## Notice of Market Rules Modification

<b>Paper No.:</b>	EMC/RCP/58/2011/307
<b>Rule Reference:</b>	Market Rules/Chapter 2 Section 4.1.1 & 6.1, Chapter 8 Section 1
<b>Proposer:</b>	Energy Market Company
<b>Date Received by EMC:</b>	23 September 2011
<b>Category Allocated:</b>	3
<b>Status:</b>	Approved by EMA
<b>Effective Date:</b>	23 December 2011

SUBJECT : **DEREGISTRATION OF A GENERATION FACILITY THAT IS NOT DIRECTLY CONNECTED TO THE TRANSMISSION SYSTEM**

**Figure 1: Example of a circuit connection that lies within the MP's premises**

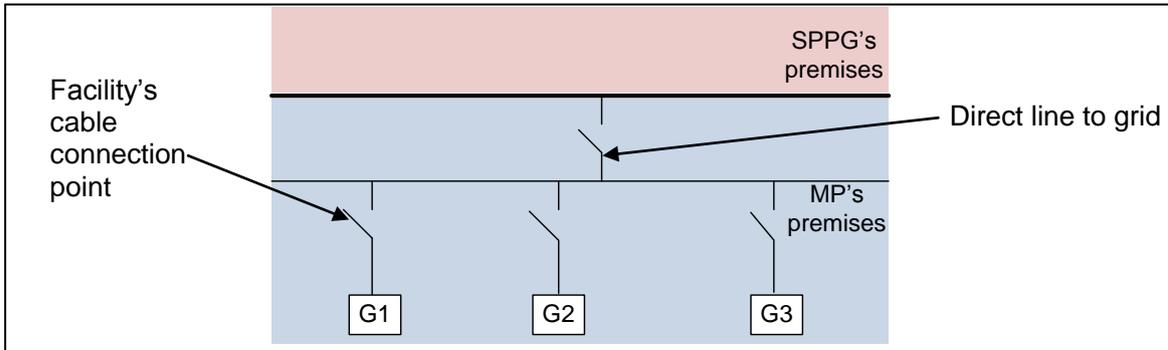
With reference to Figure 1, suppose that the MP has requested to deregister G1. Under such a scenario, SPPA is unable to disconnect the GF as it is not directly connected to the transmission system. It will also not be appropriate for SPPA to disconnect the direct line to the transmission system as that would disable G2 and G3 from conveying physical services into, through or out of the transmission system.

**Figure 2: Summary of deregistration procedures with proposed changes**

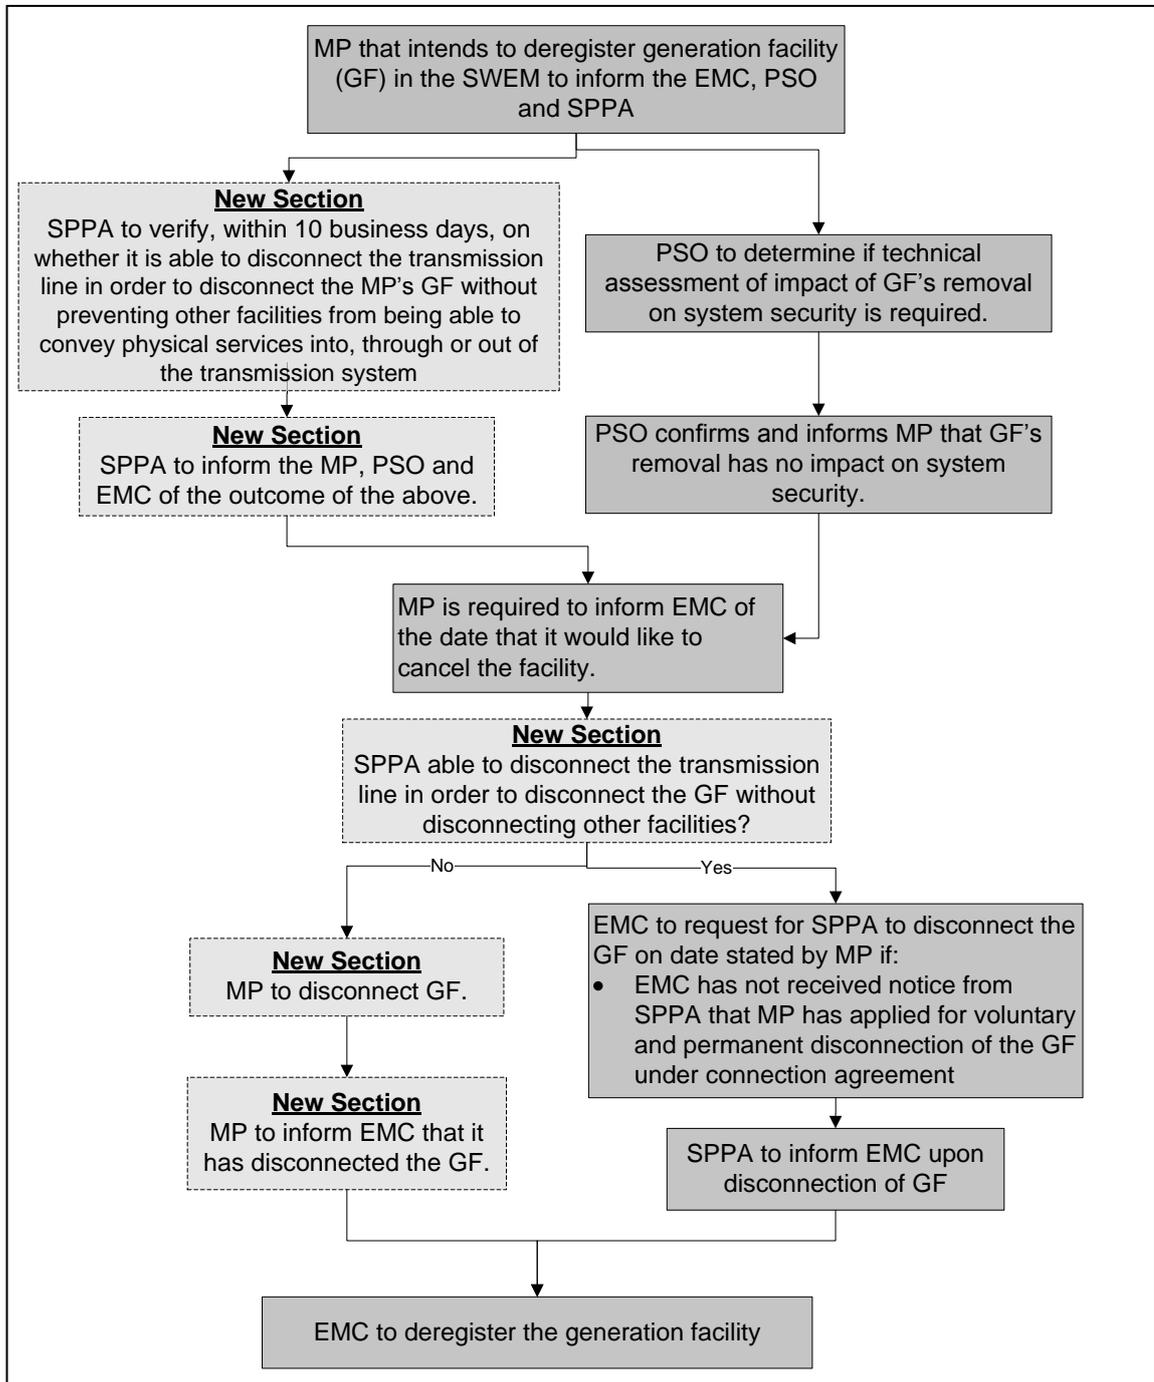
- a. **Upon receipt of MP's request for deregistration, SPPA is required to verify whether it is able to disconnect the transmission line in order to disconnect the MP's GF without preventing other facilities from being able to convey physical services into, through or out of the transmission system.**

- b. **If SPPA verifies with the MP, PSO and EMC that it is unable to disconnect the transmission line in order to disconnect the MP's GF without preventing other facilities from being able to convey physical services into, through or out of the transmission system, the MP is then required to disconnect the GF.**

- c. **Following (b), the MP is required to inform the EMC that it has disconnected the GF from the transmission system**

**Figure 3: Proposed changes to deregistration procedures**

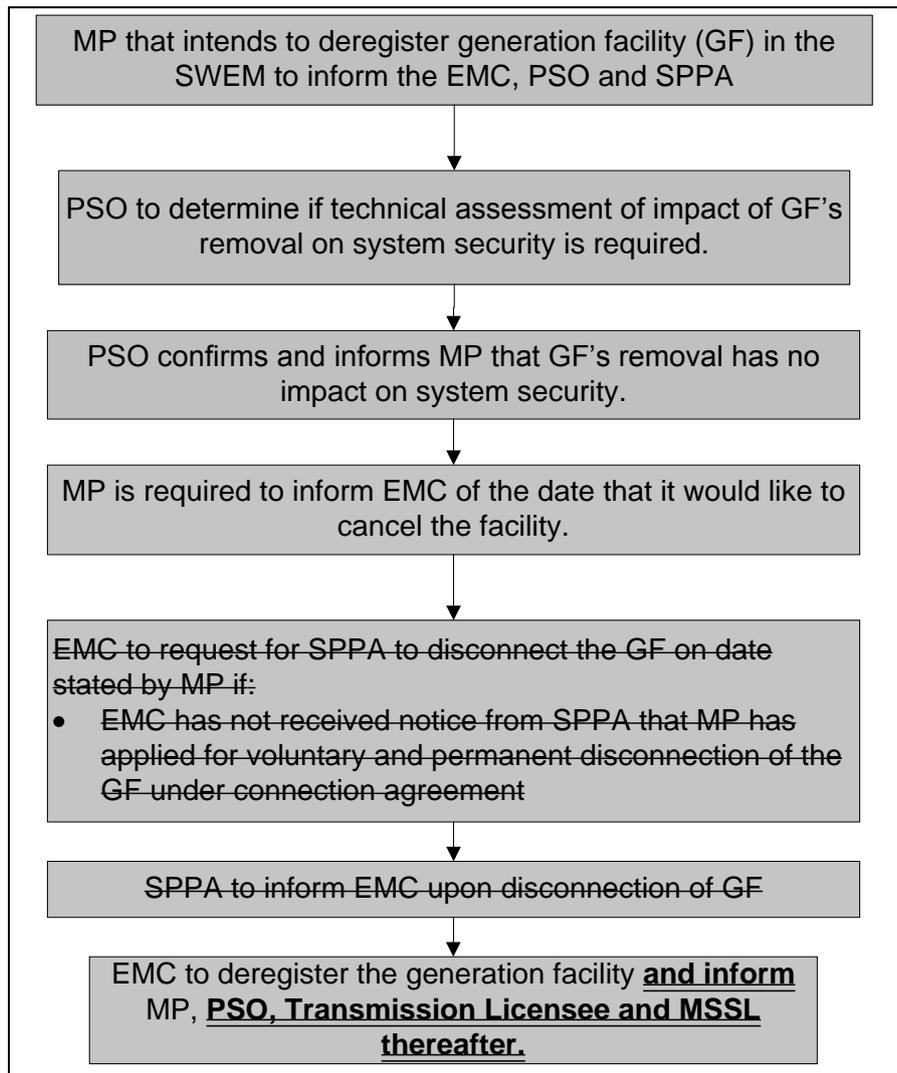
EMC thus **proposes** the following changes to the current deregistration procedures:

1. Remove the current requirement for SPPA to disconnect the GF from the grid
2. Inform the PSO, SPPA and MSSSL upon the deregistration of a GF

At the 57<sup>th</sup> RCP, the RCP **supported** the above proposed amendments to the deregistration procedures and tasked the EMC to draft rules changes to give effect to this proposal.
